2025 SPANISH GRAND PRIX 30 May - 01 June 2025

From The FIA Formula One Media Delegate Document 8

Title Car Presentation Submissions

Car Presentation – Spanish Grand Prix *SCUDERIA FERRARI HP*

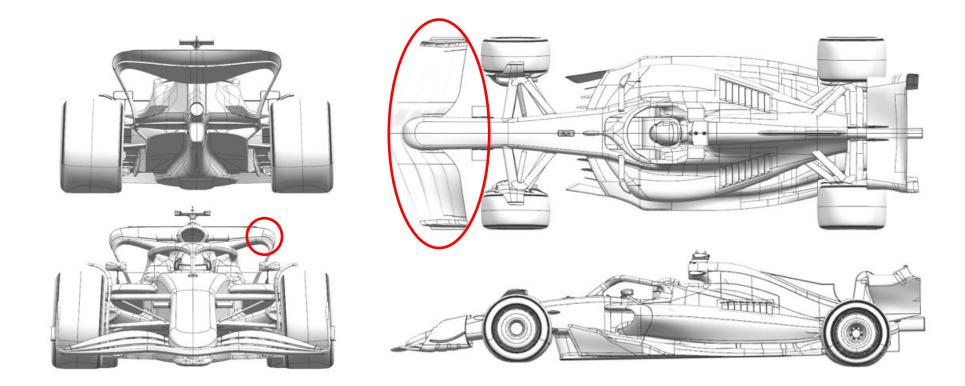
Updated component	Primary reason for update	Geometric differences compared to previous version	Brief description on how the update works (min 20, max 100 words)
1	Front Wing	Performance - Local Load	Update of chordwise and spanwise loading distribution of the wing elements, together with a revised endplate and outboard tip rolls	Not track specific, this front wing introduction is phased with the update of the articles 3.15.4 and 3.15.5 of the technical regulations, effective from the Spanish Grand Prix onwards
2	Rear Wing	Circuit specific - Drag Range	Redesign of the outboard tip and roll on the high downforce top rear wing	The high downforce top rear wing, carried over from 2024 and made available in Imola, received a local update to the outboard tip and roll geometries. Local flow features are improved, returning an efficient load increase.

Car Presentation – Spanish Grand Prix Red Bull Racing

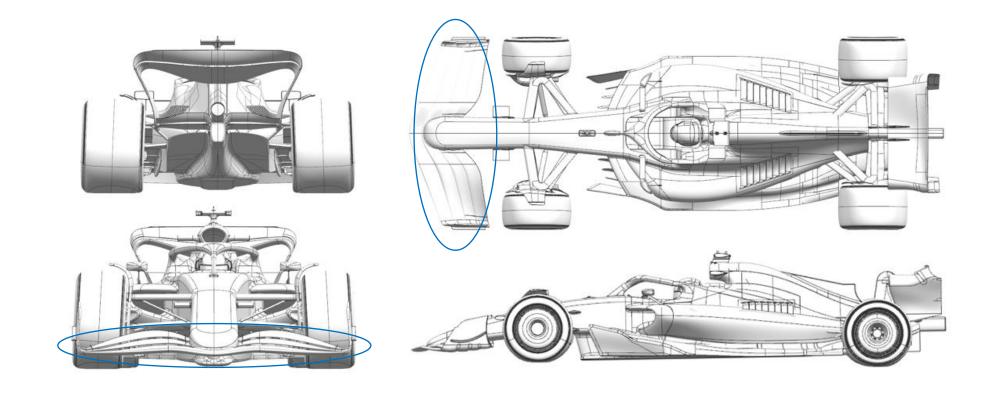
Updated component	Primary reason for update	Geometric differences compared to previous version	Brief description on how the update works (min 20, max 100 words)
1	Front wing	Performance - Local Load	First and second elements revised primarily in section. Flap elements and tips are consequential to the first two elements.	In order to comply with the revisions to the 2025 F1 Technical Regulations applicable from the Spanish GP, the front wing geometry has been revised to gain stiffness at minimal weight cost and then iterated to pursue the load characteristics sought.

Car Presentation – 2025 Spanish Grand Prix *Mercedes-AMG PETRONAS F1 Team*

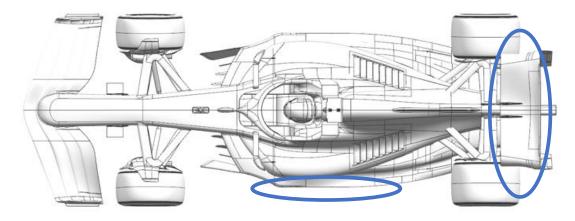
Updated component	Primary reason for update	Geometric differences compared to previous version	Brief description on how the update works (min 20, max 100 words)
1	Floor Edge	Performance – Local Load	Increased chord floor edge wing with additional vanes	Additional vane elements and flap chord increases mass flow under forward floor, increasing vorticity shed from the fence system, increasing floor load.
2	Floor Fences	Performance - Flow Conditioning	Reprofiled inboard fence	New fence profile has improved local pressure distribution and position of vorticity, improving both local and downstream load through better onset flow.
3	Rear Wing	Performance - Local Load	Reprofiled mainplane and flap elements	Circuit specific rear wing, with increased camber aimed at gaining local downforce and drag along an efficiency slope appropriate for Barcelona.

Car Presentation – Spanish Grand Prix Aston Martin Aramco F1 Team

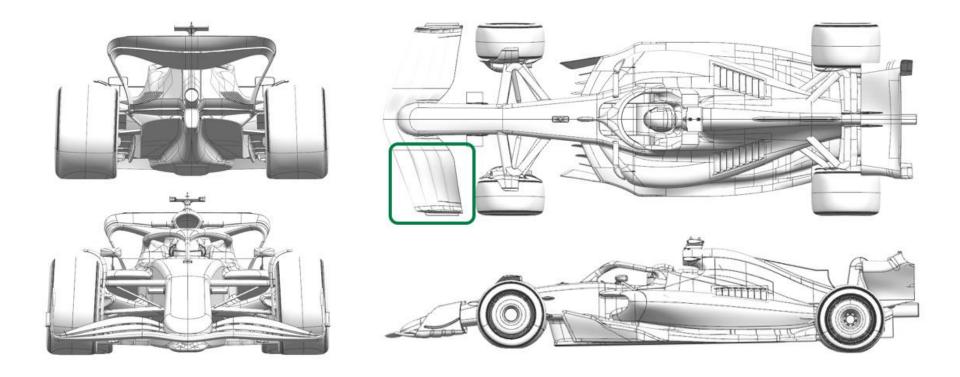
Updated component	Primary reason for update	Geometric differences compared to previous version	Brief description on how the update works (min 20, max 100 words)
1	Front Wing	Performance - Local Load	Revised tip detail between the front wing elements and the endplate. Main wing sections also revised for compliance with TD018H.	The revised tip detail improves the flowfield around the outboard end of the wing increasing the load generated in that area. Changes in section are for structural reasons.

Car Presentation – Spanish Grand Prix BWT Alpine F1 Team

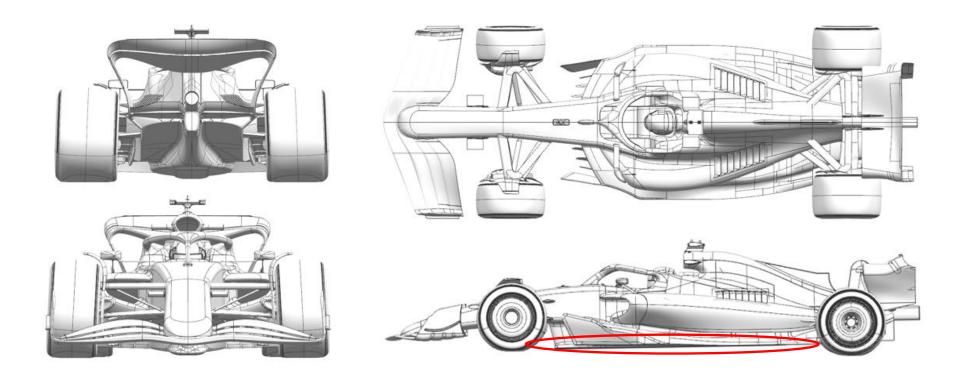
Updated component	Primary reason for update	Geometric differences compared to previous version	Brief description on how the update works (min 20, max 100 words)
1	Floor Fences	Performance – Local load	Reprofiled floor fences	The floor fences have been optimised locally to improve the quality of the underfloor structures. This results in an improved flow delivery to the entire floor and generates local load.
2	Floor Body	Performance – Local load	Local changes to the shape of the floor	Local and subtle modifications have been done to the floor to maximise the effect of the updated fences and improve the flowfield quality.

Car Presentation – 2025 Spanish Grand Prix MONEYGRAM HAAS F1 TEAM

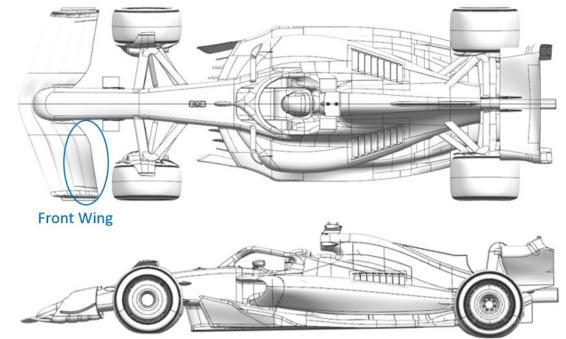
Updated component	Primary reason for update	Geometric differences compared to previous version	Brief description on how the update works (min 20, max 100 words)
1	Front Wing	Performance - Mechanical Setup	Updated Front Wing Construction	The 2025 Technical Regulations were updated on April 7 th to include more stringent FW flap deflection requirements, effective from May 28th. Consequently, a new FW construction was necessary to comply with these new requisites.

Car Presentation – Spanish Grand Prix Visa Cash App Racing Bulls

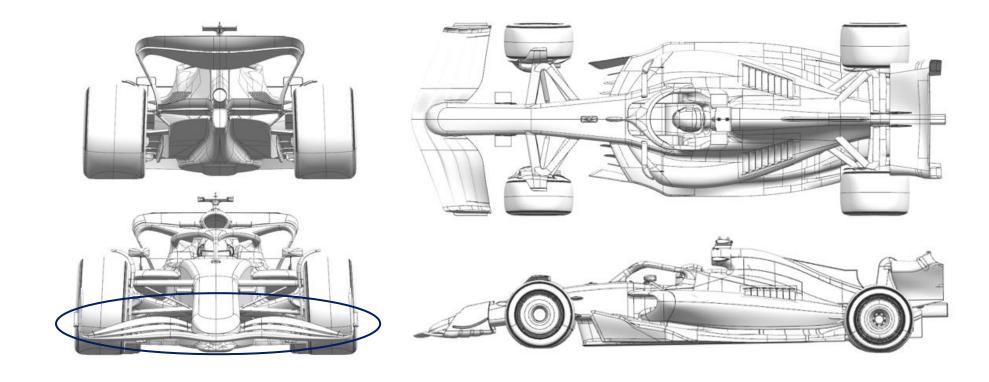
Updated component	Primary reason for update	Geometric differences compared to previous version	Brief description on how the update works (min 20, max 100 words)
1	Front Wing	Performance - Flow Conditioning	The elements of the mainplane are new, featuring a lower central section.	The centre section of the wing is loaded further relative to the outboard, modifying the downstream flow conditions. This update also addresses the increased FW stiffness requirements for race 09 onwards.
2	Front Wing Endplate	Performance - Flow Conditioning	The connection between the tips & the FWEP has been updated.	The flow around the FW tips is highly three- dimensional. The revised detail around the tips helps to reduce the losses created from this flow field.
3	Nose	Performance - Flow Conditioning	The lower surface of the nose has been raised whilst the tip has been lowered.	The nose tip drops down to meet the new FW sections, whilst the raised lower surface helps to increase the load generated by the centre section of the wing, which in turn modifies the downstream flow around the car.

Car Presentation – SPAIN Grand Prix *ATLASSIAN WILLIAMS RACING*

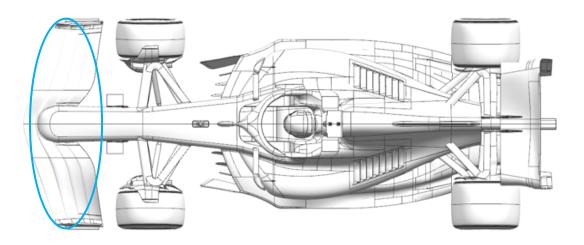
Updated component	Primary reason for update	Geometric differences compared to previous version	Brief description on how the update works (min 20, max 100 words)
1	Front Wing	Performance - Flow Conditioning	The front wing assembly is updated to satisfy the new deflection regulations. In addition, we have taken the opportunity to update the geometry of the rearward flap and FWEP. The outboard section of the rearward flap has a more backed-off profile, and the vertical section of the endplate has a revised camber geometry.	The combined geometric and construction changes reduce the deflection to adhere to the latest regulations. The geometric updates alter the flow pattern off the front wing and change the performance of both the front brake duct furniture and the forward floor.
2	Rear Corner	Circuit specific - Cooling Range	There is a revised exit geometry for the rear brake duct, which constricts the flow through the brake duct.	The revised exit geometry changes the flow rate through the brake duct and affects the brake cooling in a way that is suitable for the braking demands of Barcelona.

3	Cooling Louvres	Circuit specific - Cooling Range	A new optional cooling louvre panel is available for this event. It increases the number of large louvres to the maximum that the panel can accommodate.	This update simply increases the flow through the radiators and therefore increases the PU cooling at the cost of downforce and drag. This will be our new maximum cooling setup, which may be of use in Barcelona, but is more likely to be needed later in the season.
